Subject: Response To Application Number BR/63/19/PL at 15-17 Kew GardensBognor RegisPO21 5RD

WEST SUSSEX COUNTY COUNCIL CONSULTATION

TO:	Arun District Council FAO: Stuart Corbey
FROM:	WSCC - Highways Authority
DATE:	12 April 2019
LOCATION:	15-17 Kew Gardens Bognor Regis PO21 5RD
SUBJECT:	BR/63/19/PL Demolition of existing building and erection of 6No. three bedroom dwellings with associated accesses and car parking.
DATE OF SITE VISIT:	
RECOMMENDATION:	Advice
S106 CONTRIBUTION TOTAL:	£ N/a

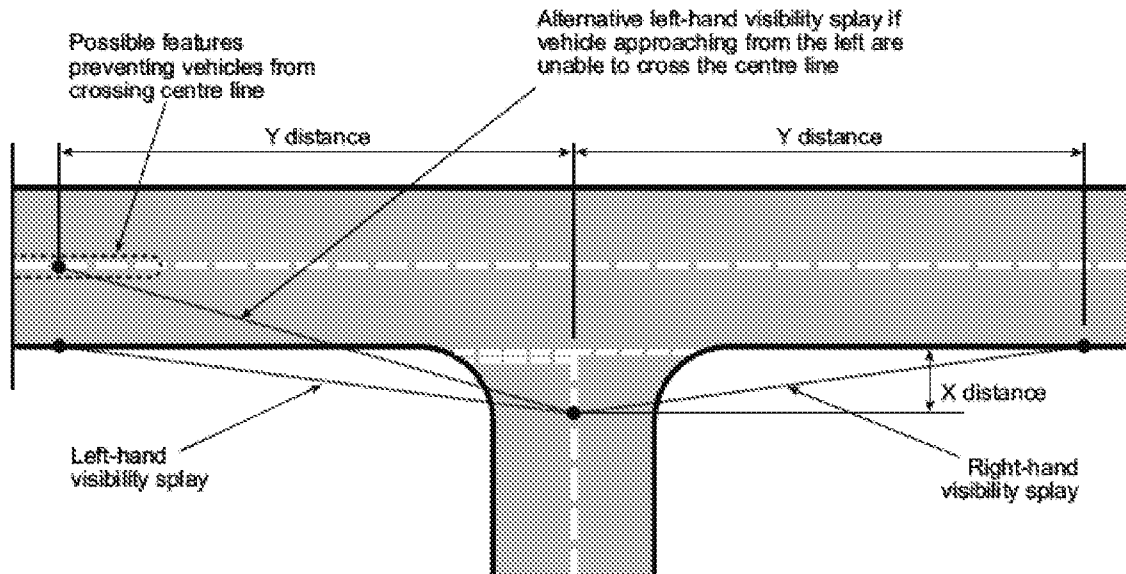
There are no initial concerns with the indicative layout. The parking allocation is anticipated to serve the likely demand generated by the proposals; any overspill parking would be anticipated to be made up via on street parking on the wider network.

A license will be required to carry out the access works onto the publicly maintained highway. I have however discussed the proposed additional Vehicular Crossovers (VCOs) with the Area Highways Manager for Arun, who has advised that applications for VCO's through a layby would likely be *refused* due to the existing parking pressures and the fact that this layby is the only dedicated on street parking location within the cul-de-sac. I advise therefore that for future advice regarding this matter, the applicant liaises with the Area Highways Manager for Arun [REDACTED]

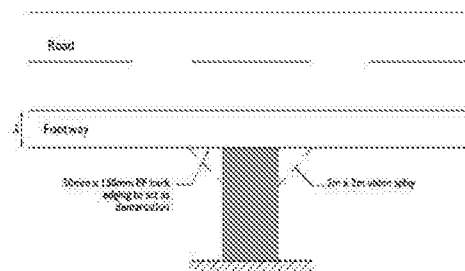
The visibility splays provided are difficult to read as the splay for each access overlaps with the neighbouring visibility splay. A clear revised plan should be provided prior to occupation, which shows the maximum achievable visibility splays from the access point. Due to the fact that Kew Gardens is a no-through road and speeds and vehicle movements are low, this would be anticipated to be sufficient for the use. These splays should be measured 2.4m back from the edge of the highway and span as far as possible to the highway edge on the same side of the road. The splays must intercept only land within the control of the applicant or the highway boundary, the property red edge does not need to include the extent of the visibility splays only the access points.

Similarly the pedestrian visibility splays have not been demonstrated, these are required to be shown 2m back into the site either side of the access and a distance measured along the back of the footway for 2m on each side of the viewpoint.

I acknowledge that the southern and northernmost accesses may not have space to accommodate the entire 2m x 2m splay due to the proximity with neighbouring properties; therefore it is advised that these are provided to best of ability within land under the control of the applicant.

No part of the development shall be first occupied until maximum visibility splays shall be provided at the site access onto Kew Gardens in accordance with a plan to be submitted to and approved by the planning authority. These splays shall thereafter be kept clear of all obstructions to visibility above a height of one metre above the adjoining road level.

No part of the development shall be first occupied until pedestrian visibility splays of 2 metres by 2 metres have been provided or to best of ability either side of the proposed site vehicular access onto Kew Gardens in accordance with plans and details to be submitted to and approved in writing by the Local Planning Authority. These visibility splays shall thereafter be kept free of all obstructions over a height of 0.6 metre above adjoining carriageway level or as otherwise agreed.
